# RFP No: CANW-1/IWAI/JMV/15

Assignment Title: Construction of Multimodal IWT Terminal at Haldia, West Bengal

# Amendment – 4

This amendment forms an integral part of the Bid Document issued on 3<sup>rd</sup> March, 2016

## 2.1.4.2 Safety Factors

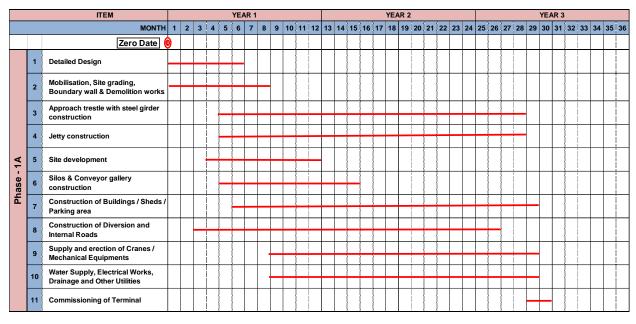
Design of the marine piles shall be carried out in accordance with the recommendations given in IS 2911, IS 14593 and IRC 78. The following safety factors shall be used to establish the safe geotechnical working load capacities of the piles as given below:

End Bearing	SF = 2.5
Skin Friction on compression piles	SF = 2.5
Skin Friction on tension piles	SF = 3.0
Lateral Load	SF = 2.0
